Evaluation of Physical Barriers – North Main Corona

Address: East Blaine St, Corona, CA 92880

Evaluation Date: 07-21-2021

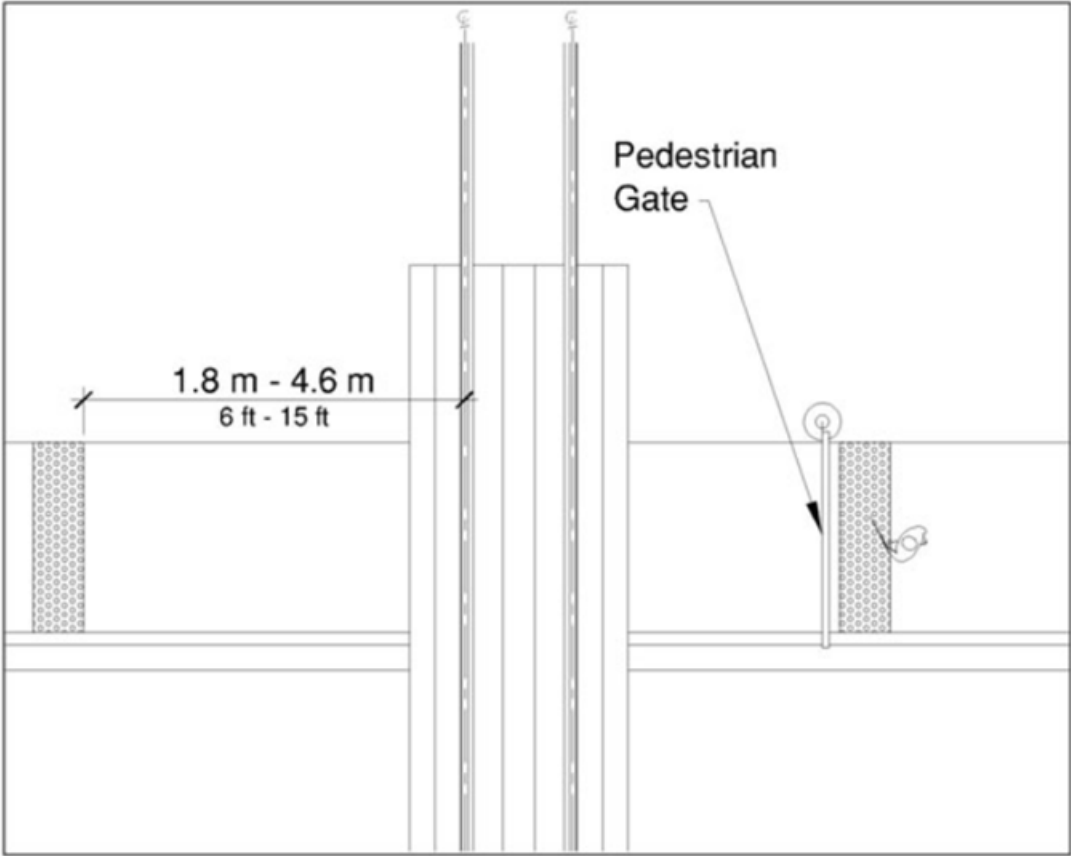
Issues/ Barriers Identified	Recommendations	Comments/ ADA Requirements
1. Curb Ramps		
1a, 1b- OK 2a - OK 2b, 2c- Not an accessible route due to curved ramps. Gate remains closed. 3a, 3b Not a required accessible route. 3a Landing is less than 36 inches. 4a, 4b- Cross slope of ramps exceeds 2 % 5a, 5c- Not a required accessible route. 5b - OK 6a Not an accessible route due to barrier arm in closed position blocking access to/from the city sidewalk. 6b- Ramp is not compliant due to uneven pavement, level changes in excess of ¼” and excessive slope. 7a, 7b- OK, but not a required accessible route. 8a – Slope of flared side of the curb ramp is more than 1:10. Curb ramp is not in RCTC’s scope.	3a- When used for providing access in the future, the landing shall be increased to be at least 48 inches deep and it shall join an accessible route. 4a, 4b. Repair cross slope. 6b. Remove the trip hazard and provide flush transitions adjacent to curb ramps if this is a designated marked crossing. See item 2. Provide signage designating the accessible pedestrian entry.	This evaluation does not include curb ramps outside the RCTC boundary. RCTC is not responsible for maintaining the accessible routes outside of RCTC boundary. When repairs begin, use proper and precise instruments (4-foot smart level and 2-foot smart level) to fit within the curb ramp width and the adjacent gutter to measure ramp slopes, cross slopes, and counter slopes at all curb ramps (all stations). The long slope of ramp shall not exceed 1:12 (8.33%). Slope of flared sides shall not exceed 1:10 (10%), the gutter slope shall not exceed 1:20 (5%). Cross slope of the ramp and landing shall not exceed 1:50 (2%) Use smart level instruments, calibrated in accordance with manufacturer’s instructions before taking measurements.

2. Pedestrian Road crossings		
a) Marked crossing at 6a, 6b is blocked due to the gate barrier. 	Remove marking if the pedestrian route is now closed to public and other pedestrians. Provide signage for the alternate accessible route.

Issues/ Barriers Identified	Recommendations	Comments/ ADA Requirements
b) Crossing from 1a to 5c is not on the accessible route and is marked. Sign identifying 1a, 1b as the accessible route is missing.	Provide sign identifying 1a, 1b as the accessible route
